**SOIL/SITE EVALUATION
 for ON-SITE WASTEWATER SYSTEM**

SITE PLAN APPROVAL SFD

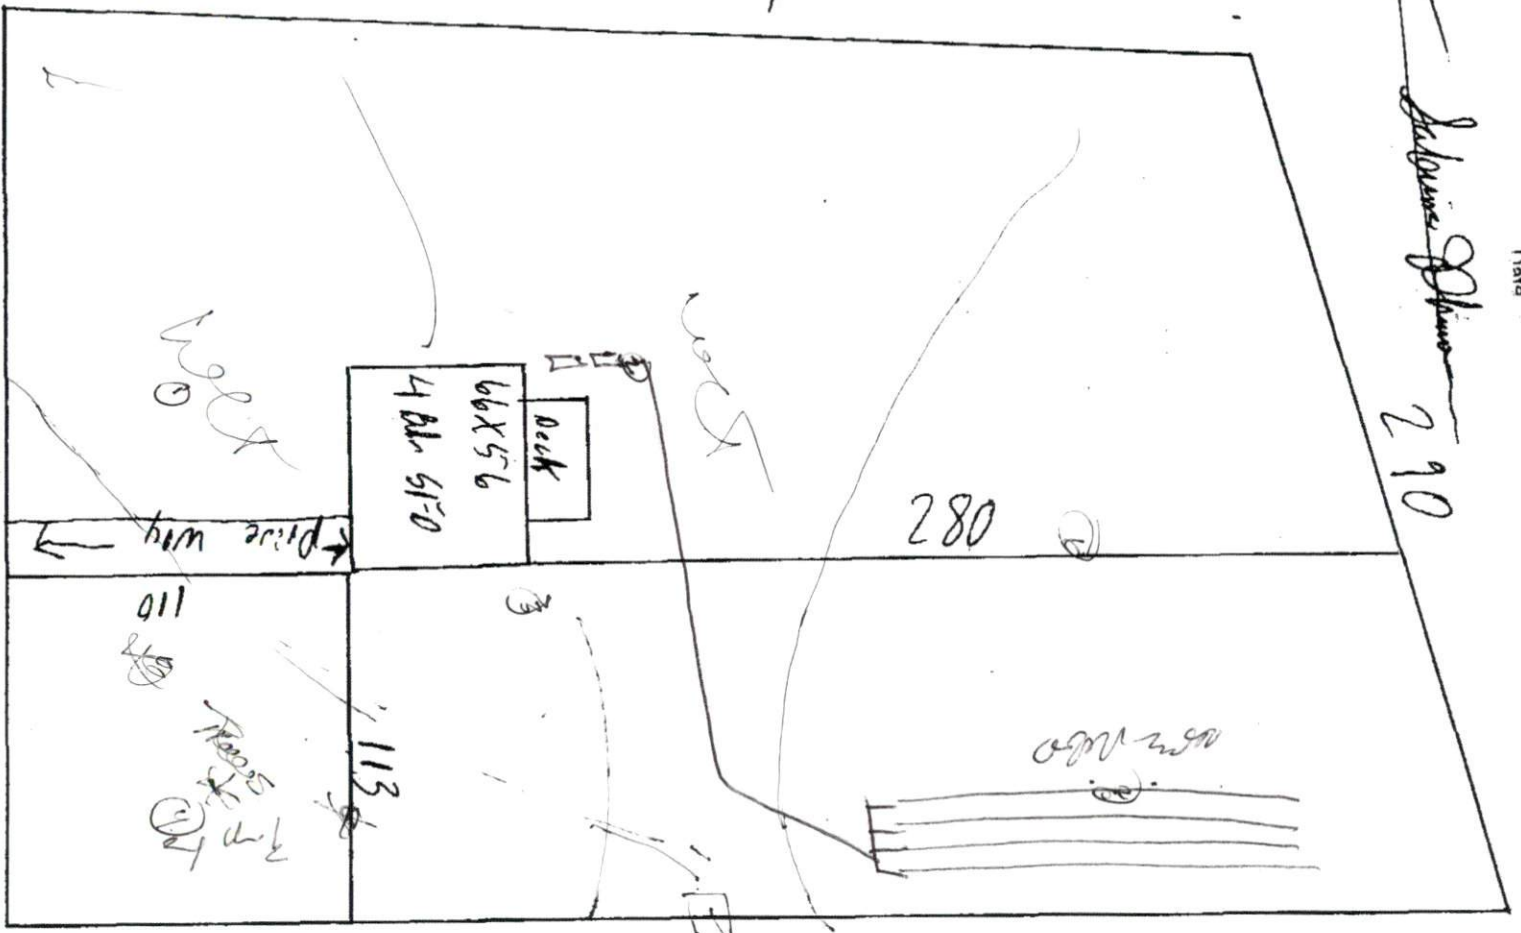
Needs better front

wells

add more space
